**STAFF REPORT: 10/12/2022 REGULAR MEETING**

**APPLICATION NUMBER: #22-8056**

**ADDRESS: 4290 LESLIE**

**SCOPE: REHABILITATE DWELLING, INSTALL FENCE (WORK COMPLETE WITHOUT APPROVAL)**

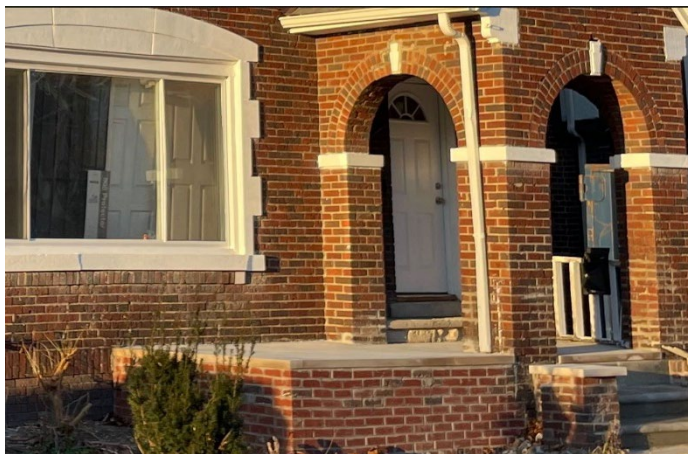
- Asphalt shingle roof replaced with asphalt shingles, wood fascia and soffits replaced with vinyl, all windows replaced with vinyl windows, front door replaced, front porch altered brick cladding and railing replaced, and installation of rear privacy fence.

*Site Photo 7, by Applicant exact date unknown 2020: (North) rear elevation showing condition of house after purchase.*

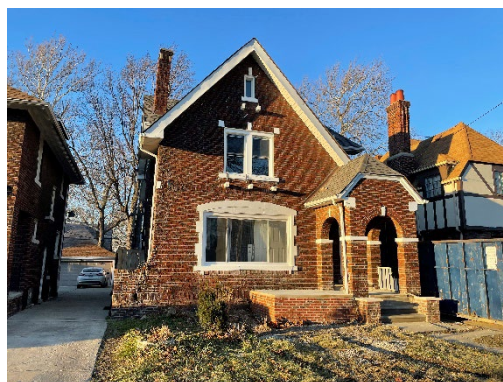
- The applicant was not able to provide a clear count of aluminum windows removed nor their specific locations. Staff observed that the front windows of the third and second floor has been changed to vinyl windows between 2020 and December 2021. (See photos 6 & 8).

- Staff observed in the 2020 photo provided by the applicant the original darker brick facing of the front porch was present, but some of the rebricked area is not clearly visible in this photograph. (*See photo 6*)
